RE: Data Response, Set 2B  
Ivanpah Solar Electric Generating System (07-AFC-5)

# **Ivanpah Solar Electric Generating System (ISEGS)**

## **Data Response, Set 2B**

**FIGURE DR131-1**  
**CONSTRUCTION LOGISTICS AREA**  
 IVANPAH SOLAR ELECTRIC GENERATING SYSTEM

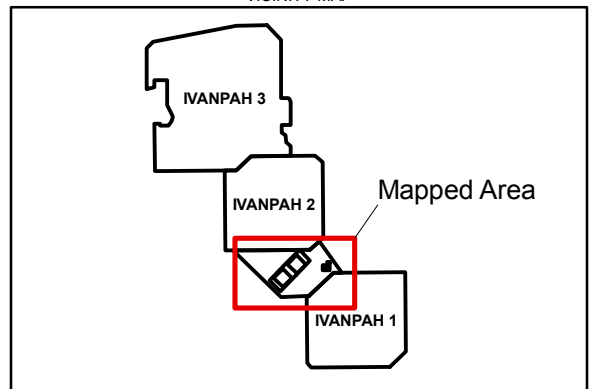
**Response:** During the June 23<sup>rd</sup> workshop, additional clarification was requested about use of the area between Ivanpah 1 and 2 and the acreages contained in Tables 5 and 6 of Attachment DR131-1. Tables 5 and 6 are reprinted below with modifications to the numbers shown in **bold text**. In addition, Table 7 has been added along with Figure DR131-1 showing the acreage between Ivanpah 1 and 2 and providing a description of the uses of that area.

**FIGURE 139e-1**

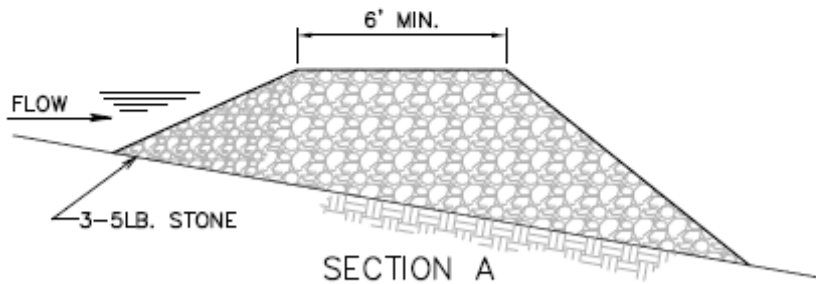
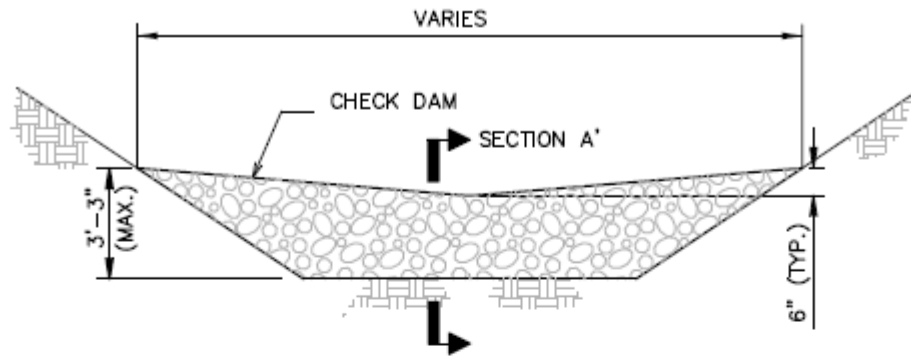
- e. Please explain in writing and with illustrations how the principles of Low Impact Development would be integrated into the final grading plan.

1. SEDIMENT TRAP TO BE CLEANED OUT WHEN VOLUME BECOMES HALF FULL.
2. ROCK FILTER TO BE INSPECTED & REPAIRED AS NEEDED.
3. STONE SIZES RANGE FROM 0.75 TO 5 INCHES. (CLEAN OF FINES)
4. THESE STRUCTURES ARE USED FOR DRAINAGE AREAS UP TO 5 ACRES.
5. ROCK FILTER DAM SHOULD BE KEYED INTO SWALE OR CHANNEL BOTTOM AT A MINIMUM OF 6 INCHES.
6. CONTRACTOR TO USE NATIVE STONE AS AVAILABLE.
